**REQUEST FOR TENDER
ORANGUTAN OUTDOOR EXHIBIT CONSTRUCTION
RFT#: TZC T 57-2019-12
ADDENDUM # 2**

Date Issued: 2020 January 15
Project Name: **Toronto Zoo Orangutan Outdoor Exhibits**
To: Ben Knoop
Toronto Zoo
361A Old Finch Avenue
Toronto, ON M1B 5K7
Project Number: 18-1-086
RFT Reference No.: TZC T-57-2019-12 (issued 2019-12-17)

ADD #A002

S-700

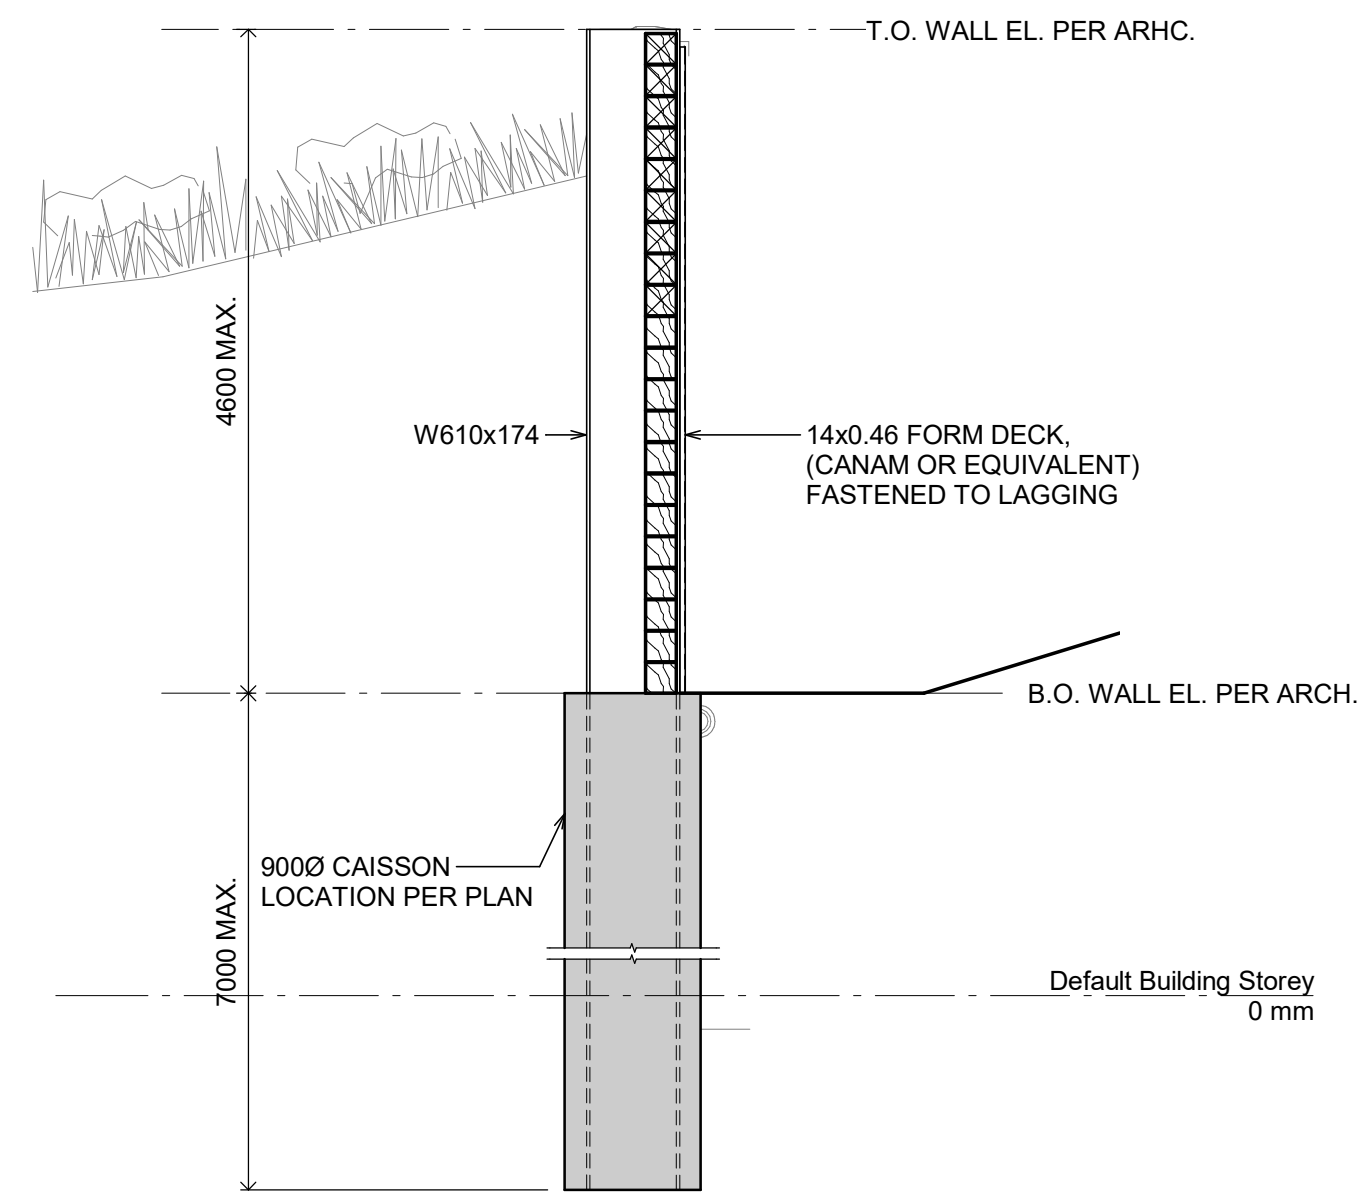
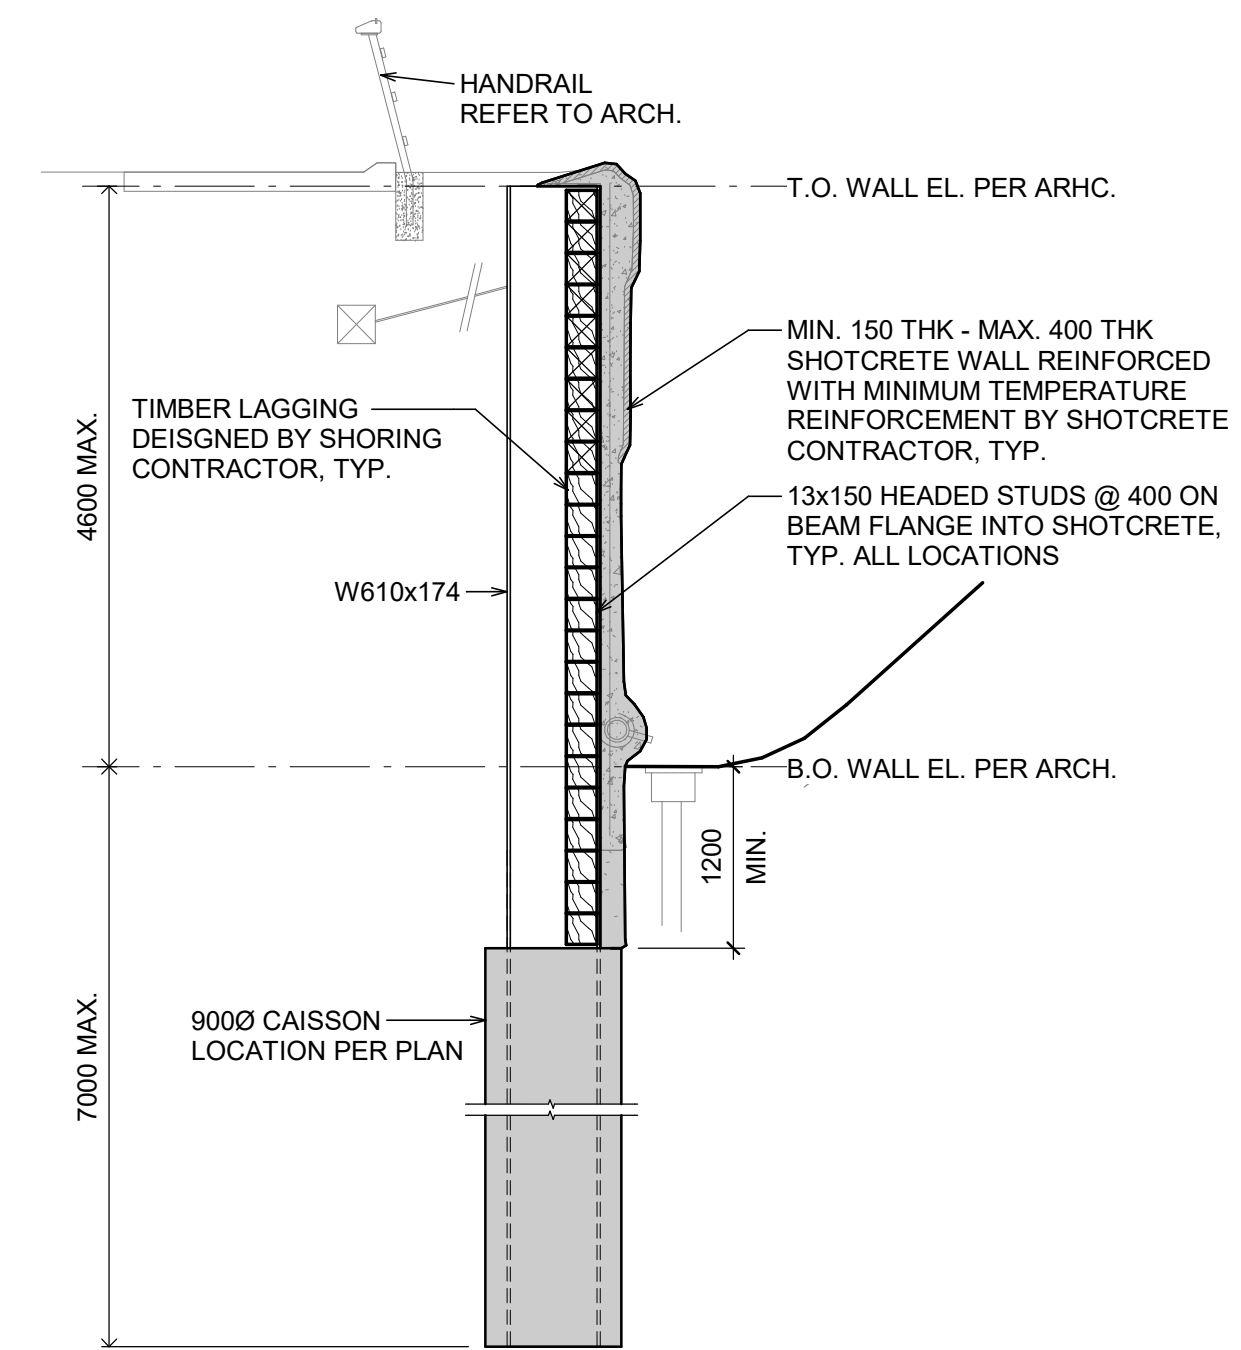
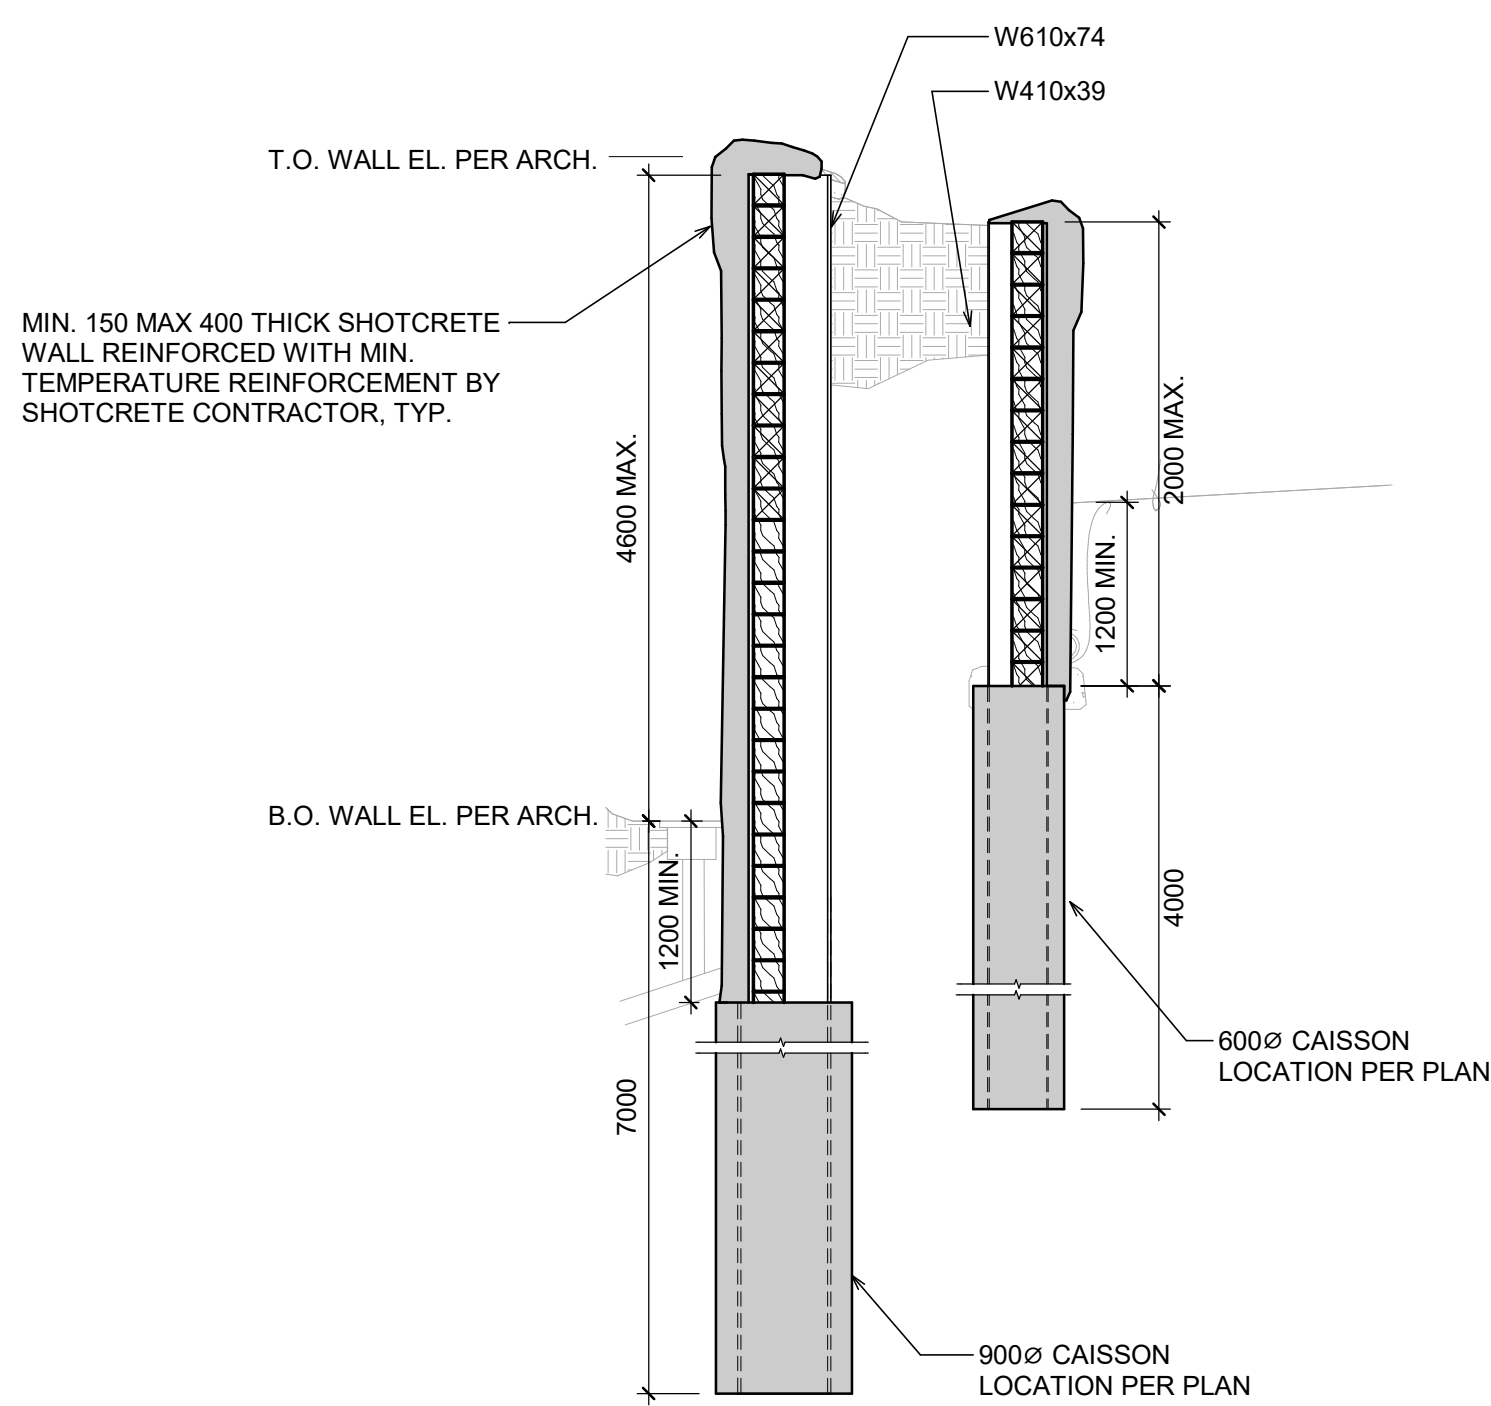
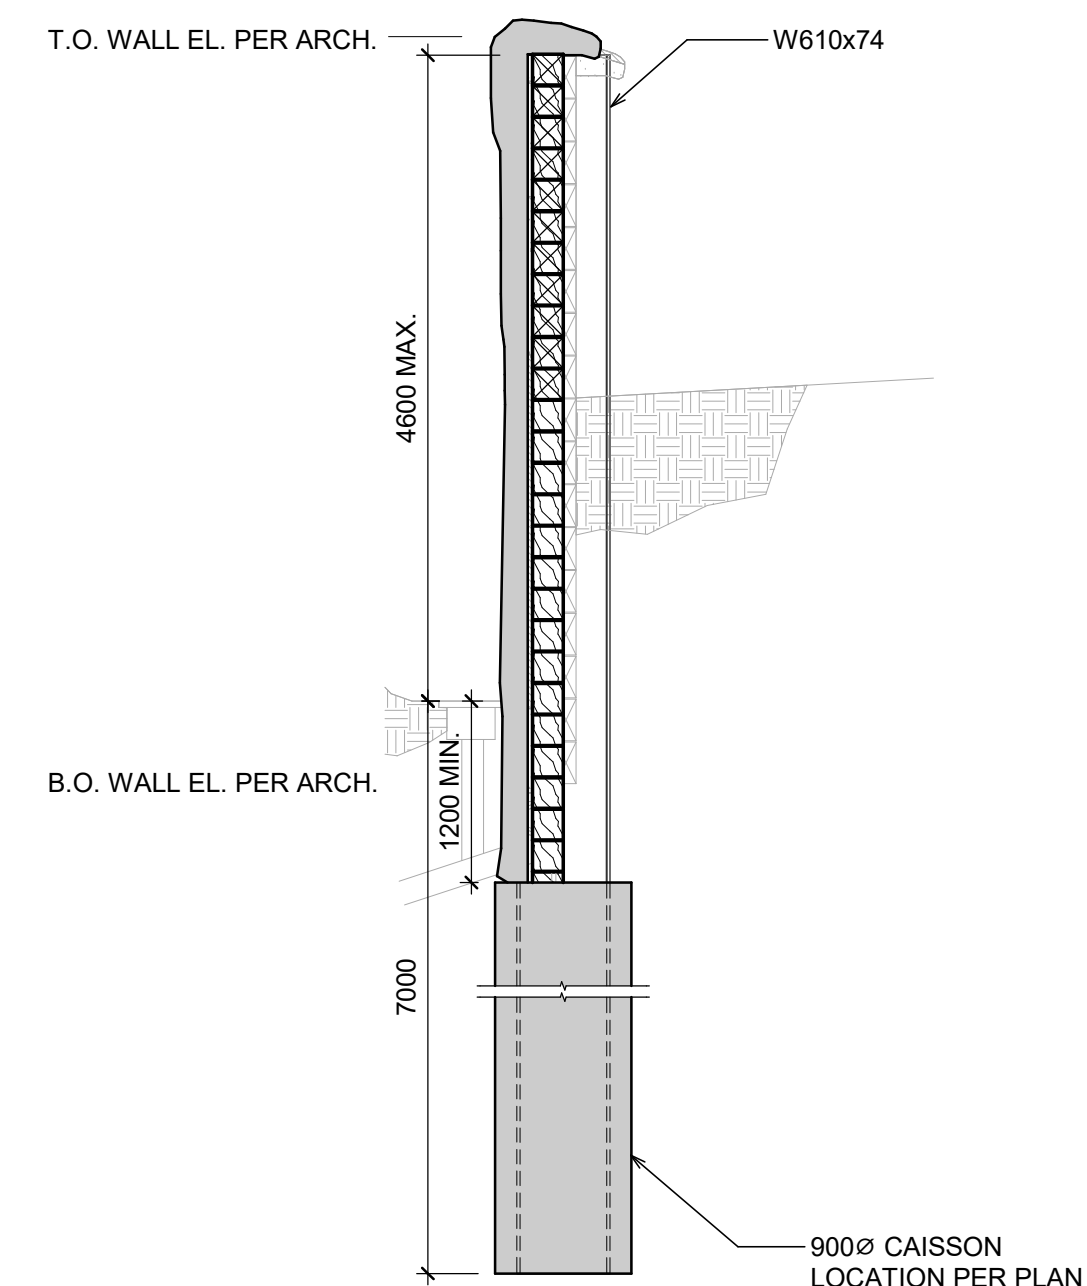
01.08.C	C		
1 (S)	Are there shoring drawings to bid with? Or is the structural foundation plan paired with the civil plan elevations what is to be used for tender purposes	S-200C and S-700 are sheets related to the shoring. The details and concepts on these sheets were provided for pricing and intended to be used as a concept only. Final shoring design should be completed by the shoring contractor. These drawings should be used in conjunction with the civil drawings to determine the finished grade elevations.

Date Discipline	Description	Answers	Additional information
8 (C)	Regarding to shoring part in habitat 1 (drawing# S-700), can you please specify top of wall, existing grade, bottom of wall and bottom of caisson's elevation for each section. Related elevations cannot be figured out from architectural drawings.	See Civil grading plan	
9 (C)	Regarding to shoring part in habitat 1 (drawing# S-700), there is 1.2 m gap between bottom of wall and bottom of excavation in all sections except section 2. Would this 1.2 m be backfilled after a shoring?	<p>Yes, these are to be backfilled. Bottom of wall shown on drawings.</p> <p>Structurally, the 1.2m is shown to locate the bottom of the shotcrete wall below the frost line.</p>	
10 (A)	10. Is there any 3D perspective from completed project to have a better vision on that?	No	
11 (C)	The note on the CV-003 Grading drawing says. With in the Exhibit to be per contour lines. The grading drawing shows both contour and existing elevations and both do not match each other. Please clarify which Grading elevations consider as existing elevations.	<p>Contours shown are proposed elevations.</p> <p>Light gray spot elevations are existing.</p>
